Peer Review File

REVIEWER COMMENTS

Fig. R1. Laplace block diagram of the aggregated model for frequency response

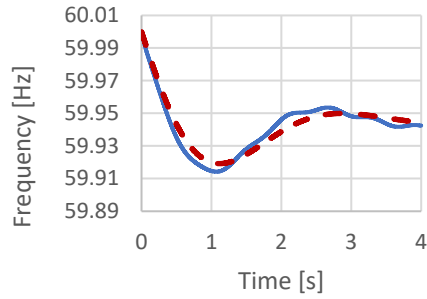
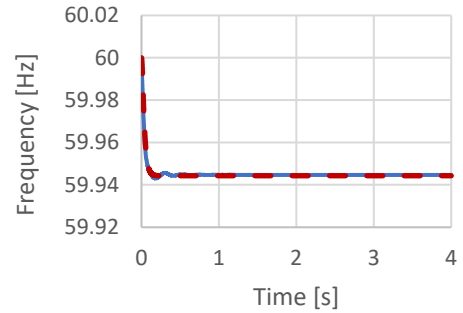
Reviewer #1, Comment 4: The study is based on an excellent approach of the very complex research questions concerning the grid stability in the future which are initiated by the transition from a synchronous generator-based grid operation to a new one which is nearly 100 % inverter-based with renewable generation. No conclusions, claims or additional evidences are necessary. But a more clear nomenclature, especially for the different frequencies mentioned in point 1c, is necessary, especially for distinction between rotor damping and droop frequency control. A control scheme in Laplace domain could be helpful.

> **Author's Response:** We appreciate your recognition of the merits our paper has to offer. And thank you for your suggestion about the nomenclature. Accordingly, we have added a nomenclature for the different frequencies mentioned in point 1c. We hope the esteemed reviewer finds this addition satisfactory.
>
> In the revised Supplement Material, we also have added a **Laplace block diagram** of the control processes that forms the aggregated model we used for synchronous generator and the multi-loop grid-forming technology, as shown below, in Fig. R 1.

Fig. R4. Average value of the damping power as a function of speed deviation, from [R1]

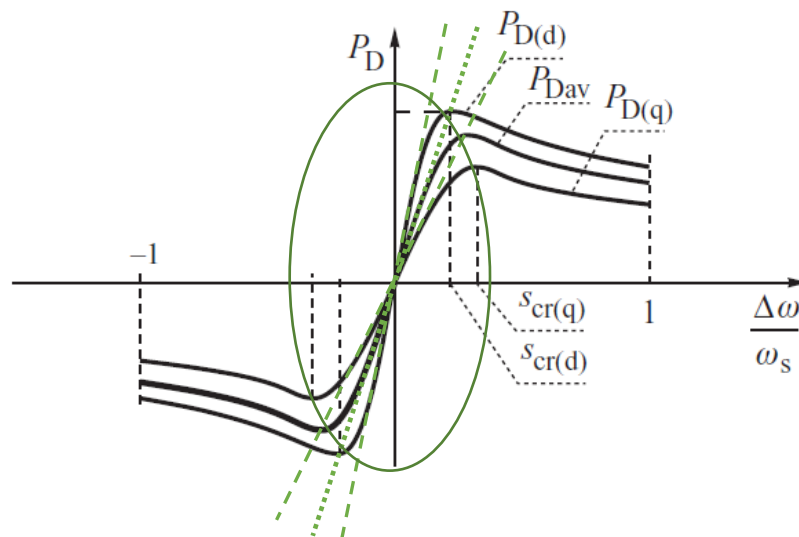
Reviewer #1, Comment 5: In reality the rotor damping is completely decoupled from the droop control (there is a natural damping of the rotor in case of Δωi≠0). The transfer function for rotor damping of the damper cage is not constant as assumed in equation (3) and (8). The characteristic is like a filter with an input signal coming from rotor oscillation (Δωi ≠0) with a time delay (parameter: complex synchronisation coefficient in real synchronous machines, Weh, ff. Elektrische Netzwerke und Maschinen in Matrizendarstellung, BI/108/108a, 1968).

Author's Response: The esteemed reviewer highlights a very important point here. The droop damping is a constant, but the damping torque in the synchronous generator provided by the damper windings can vary slightly with the change of rotor angle. However, the damping power produced by the damping torque can be analyzed as a function of speed deviation, as shown in Figure R2. When Δω=0, both d and q factors are equal to zero and the overall value of damping loss increases proportionally to the speed deviation for small speed deviations.

Since we study small-signal stability, referring to small perturbations, we are interested in the neighborhood close to Δω=0 where the difference between d, q, and the average value is insignificant (shown in the green circle in Fig. R4).

To summarize the abovementioned points, for network studies it is the convention to assume the $D_m(\delta) \approx D_m$ as a constant value, a precedent set by J. Machowski el at [R1] and P. Sauer el at [R2] (two main reference textbooks of the field of power network dynamics), for two reasons. (1) the variations of damping power are linear within the regions near the origin and (2) the small, bounded variations of D_m with changes of δ simplify the problem,

Fig. R5. Validation of the analytical model using full-order models implemented in an industry-grade power system planning software for electromagnetic transient modelling (EMT) dynamic modelling

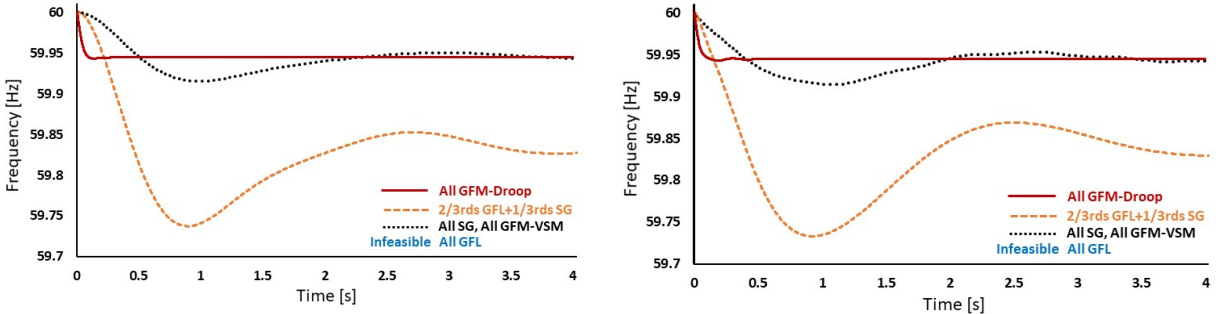
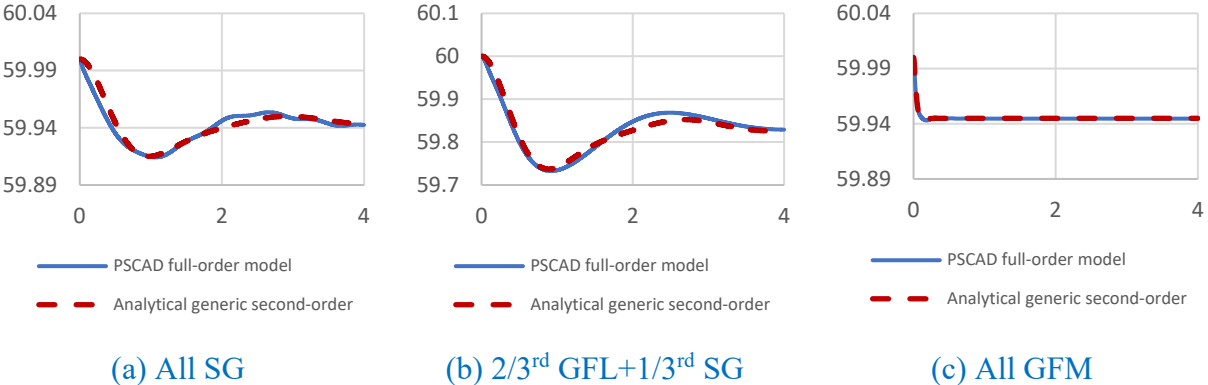
Reviewer #1, Comment 6:. The used linearized model is valid only for small signal operation which is not completely realistic.

Author's Response: We agree with the esteemed reviewer on this point for further validation of the findings of this paper and the need for experimental results. For power grid analyses at the system level, it is always difficult to acquire experimental data because the power grids are intertwined with security and financial systems and, hence, there exist extensive restrictions around conducting experiments on the system itself. Because of this, the system planners and operators all around the world mainly rely on very granular modelling using industry-grade software packages. And we find it reasonable to follow the same procedure and provide further industry-grade simulations for validation purposes.

In the revised Main manuscript, we have provided additional simulation results, shown in Fig. 4 of the Main document, and have been able to successfully validate and verify our analytical model presented in this paper using the PSCAD industry-grade models of the IEEE 9-bus system, as shown below in Figs. R5 and R6. It can be seen the frequency response traces virtually match.

Figure R8. Timescales in electric grid dynamics and operation, borrowed from [R2]

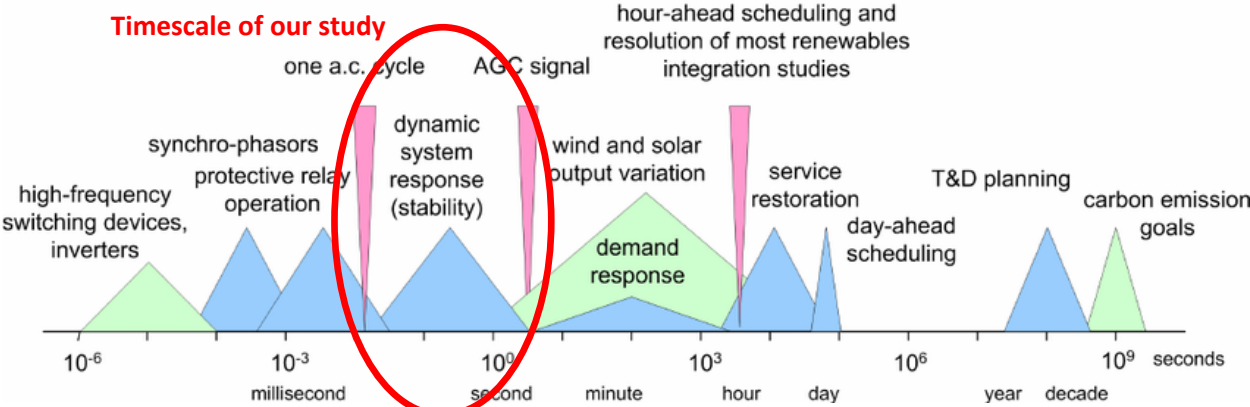
Reviewer #2, Comment 4: Damping is, essentially, a very fast primary control. While this can be achieved by power electronics easily, it is not the case for conventional generators, and in periods of low RES production, if conventional backup generators must be brought online, the control of the system may be in danger. Also, if a demand-supply unbalance is kept for a relatively long time, huge amounts of storage will be needed, which may not be cost-competitive, at least in the short run, with conventional control strategies. All these issues can not be addressed in the framework of the studied model, but at least it should be discussed in the manuscript.

Author's Response: We recognize the operational challenges that the esteemed reviewer raises to fall under the "energy imbalance" problem, which in power system planning is commonly called the resource adequacy problem, to ensure that MW generation (both to dispatch and for reserve) matches the forecasted consumption and in real-time market operation is known as the resource sufficiency problem. In this form it ensures that capacity and ramping capability among balancing authorities within a footprint exist. Of course, all these issues are part of a larger decarbonization portfolio that cannot be addressed in one paper.

In this work we do not try to address "the balancing problem" associated with renewable generation, only "the inverter problem", as laid out by P. Denholm et al [R1]. The timescale of interest in the present paper is cycles to seconds, establishing feasibility and necessary conditions for the synchronized operation of an interconnected power network encompassing various synchronous generators, grid-following inverters, and grid-forming inverters.

Overall, power systems have temporally separated sets of decision-making that required multi-timescale measurement and operations. Figure R8 summarizes the multi-temporal dynamics of power system and highlights where in this spectrum our analysis falls.

Figure R9. Timescales in electric grid dynamics and operation, borrowed from [R2]

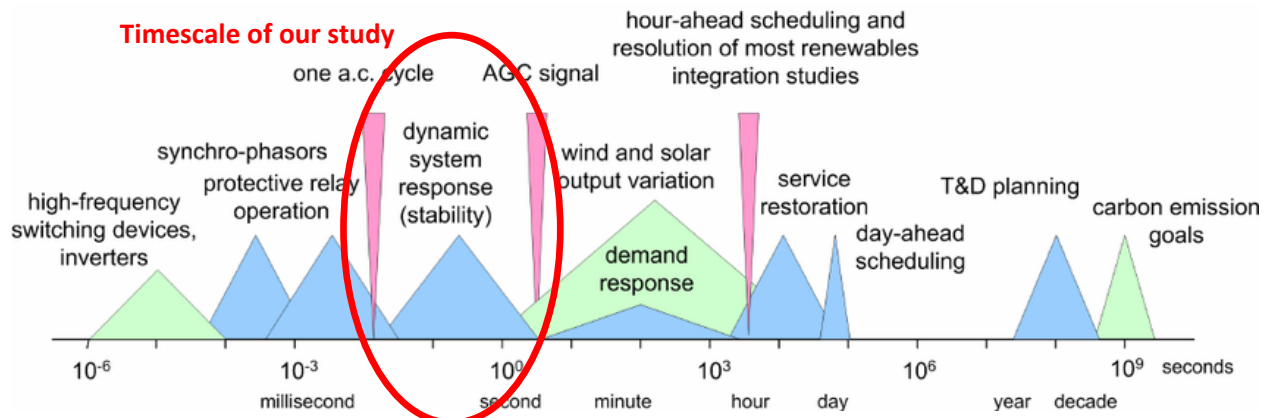
Reviewer #3, Comment 13: The authors claim "this confirms the feasibility of operating electric power networks on 100% renewable based generation". However, they have only shown that power grids can synchronize using inverter-based technology. While the authors claim that on the time scale they are interested in (and do not specify) the load will not change, renewable generation can easily change on the time scale of few seconds, minutes etc. None of the results presented here tackle the balancing problem of renewable generation. Hence, I urge the authors to make their claim more moderate and specific to fit what they have actually shown.

> **Author's Response:** We completely agree with the esteemed reviewer. The timescale of frequency response is cycles to seconds, as reflected in the results shown. We agree that this paper tackles a problem that is a part of a larger portfolio necessary to transition to 100% inverter-based operational capability, namely part of the "inverter problem", but not any part of "the balancing problem" as laid out by P. Denholm el at [R1]. The power balancing issue however fall under different timescales of seconds to minutes and even years. Planners study that problem under resource adequacy in order to determine the capacity necessary to build years ahead, and the operators look into this problem under unit commitment for day(s) ahead and resource sufficiency among the balancing authorities to ensure the generation capacity, reserve margin, and ramping capability are available to meet the demand. Indeed, we did not intend to address all of the challenges of a transition to a 100% renewable grid, many topics are still open questions such as power limiting, fault detection and diagnosis, power sharing, ancillary service and market operation to hedge the risks associated with the variability and uncertainty inverter-based resources.

>
> Overall, power systems have temporally distributed sets of decision-making that required multi-timescale measurement and operations. Figure R9 summarizes the multi-temporal dynamics of power system and highlights where in this spectrum our analysis falls.
